# PROJECT REPORT

Groundwater Modelling Report – Rosehill Service  
Facility

Sydney Metro West – Western Tunnelling Package

Figure 8.1 Predicted long term drawdown

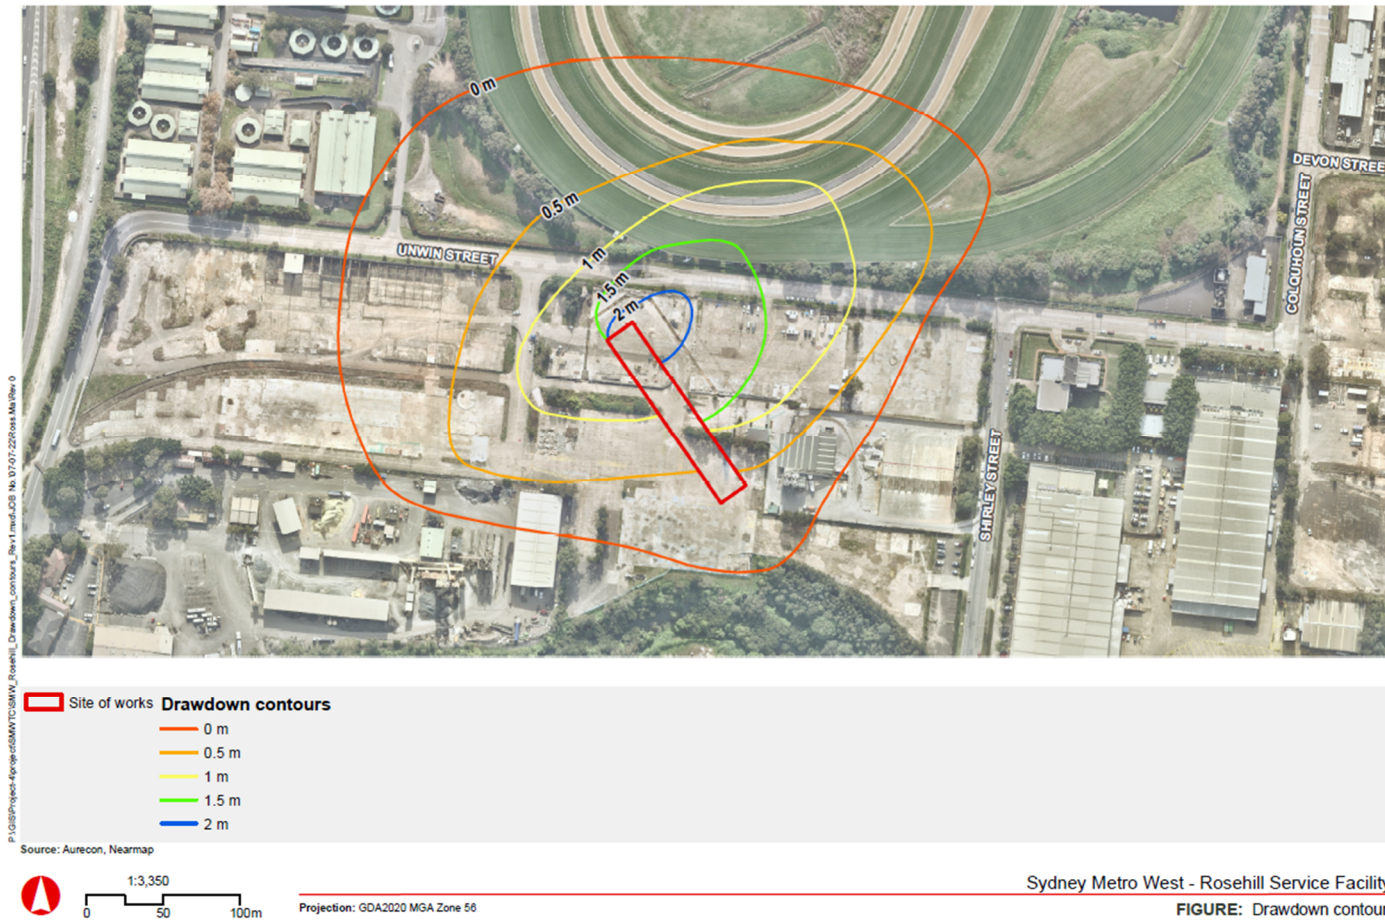
**Question 1:** *The drawdown is stated at less than 1m and of very limited extent, By comparison the Site wide HIR shows much greater drawdown extent at Parramatta (also a D-Wall) and at Clyde Dive access shaft,*

**Question 5:** The generated groundwater drawdown contours for the Rosehill Service Facility were symmetrical and did not account for the recharge influence of Duck Creek.

**Answer 1:** Additional cross sections have been compiled in the Slide2 model to provide additional data points to better represent the drawdown contours. Figure 8.1 has been amended accordingly with the maximum drawdown of 2.1m adjacent to the D-Wall with drawdown reducing asymmetrically away from the D-Wall due in response to the differential recharge influence from Duck Creek.

**Answer 5:** Figure 8.1 showing predicted groundwater drawdown has been amended. The revised contours are based on three cross sections through the excavated structure with engineering judgement applied to complete the contours. Recharge from Duck Creek is applied with a constant head boundary. As expected the contours are elongated on the north western side of the structure where the influence of recharge from Duck Creek is diminished.
